INDEPENDENT SEISMIC DESIGN VERIFICATION  
TURBINE DRIVEN PORTION  
EMERGENCY FEEDWATER SYSTEM

V.C. SUMMER NUCLEAR STATION

FINAL REPORT: OCTOBER 15, 1982

prepared for  
SOUTH CAROLINA  
ELECTRIC & GAS COMPANY

FIGURE 5-1  
SIMPLIFIED EMERGENCY  
FEEDWATER FLOW  
SCHEMATIC

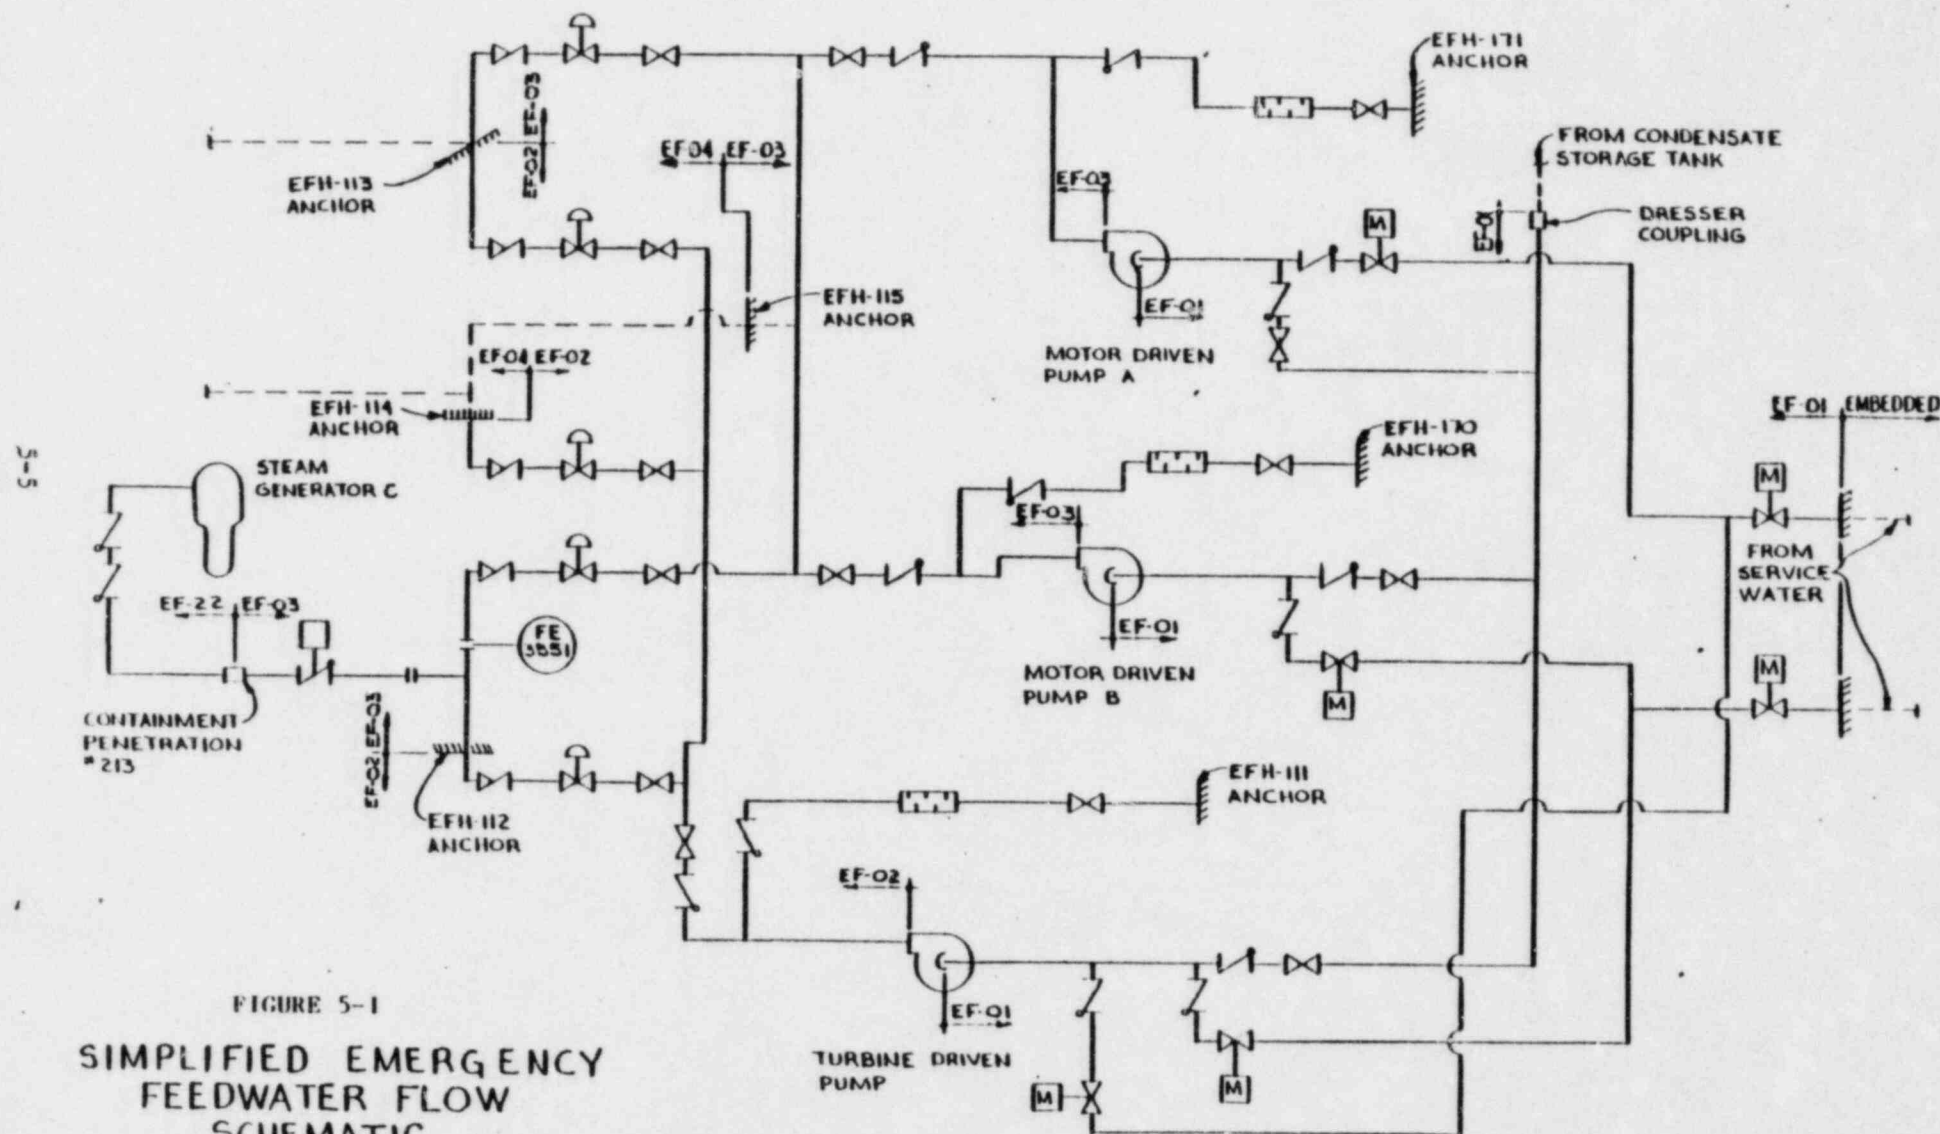
1. The isometrics covering subsystem EF-01 specifies the enveloping of Figures 61, 62 and 64. The pipe stress analysis package indicates only Figures 61, and 62 were enveloped. There was no documentation in the package to indicate why Figure 64 had not been used. An RFI (TES-0082) from TES which addressed the deletion of Figure 64 was located in the GAI files. This RFI was approved by GAI. However, the package did not reference the RFI nor was there evidence that TES had marked up the ISO (as required by the interface procedure) to show the deletion of Figure 64.

2. The pipe stress analysis package for subsystem EF-02 indicates that Figures 7, 8, 61, 62 and 64 are used in the analysis. Figures 7 and 8 are for the Reactor Building and Figure 64 is for elevation 463 of the Intermediate Building. Subsystem EF-02 terminates in the Intermediate Building and does not extend to elevation 463 of the Intermediate Building. Therefore, it appears that the use of Figures 7, 8 and 64 was not necessary.

3. The pipe stress analysis package for subsystem EF-03 indicates that Figure 64 (elevation 463 of the Intermediate Building) was used in the analysis (along with Figures 7, 8, 61 and 62). EF-03 piping does not extend to elevation 463. Therefore, it appears that the use of Figure 64 was not necessary.
